Fire Resistant Coating Details (Ramp Slab Soffit):

R1: Updated Traffic coating	
Date: 07/28/2026	Not to Scale
Project: Village at Palisades, Bldg 5, Olympic Valley, CA	
Subject: Fire Coating and Traffic Coating Details	
Drawing Size: Arch C	Drawing Number: SD3B_R1
 Concrete Science, Inc. INVESTIGATION TESTING ENGINEERING	
1534 B St., Hayward, CA 94541	
Tel: (510) 581 2342 Email: info@concretescience.com

Sketch 1

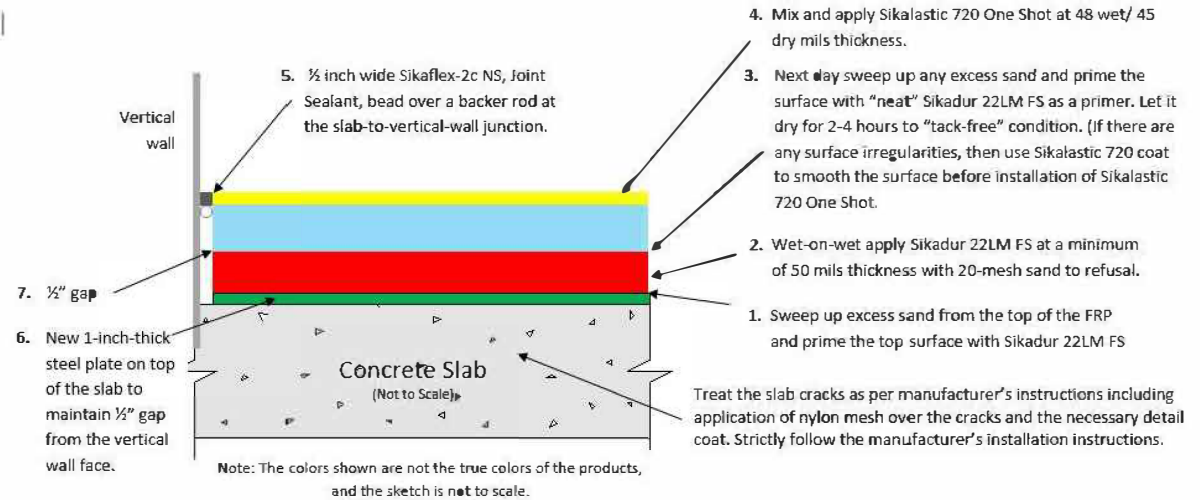
1. Traffic coating as per sketch 1. The traffic coating shall extend 5 feet beyond the top FRP installed at both ends along the traffic direction of the ramp. Strictly follow manufacturers installation instructions.
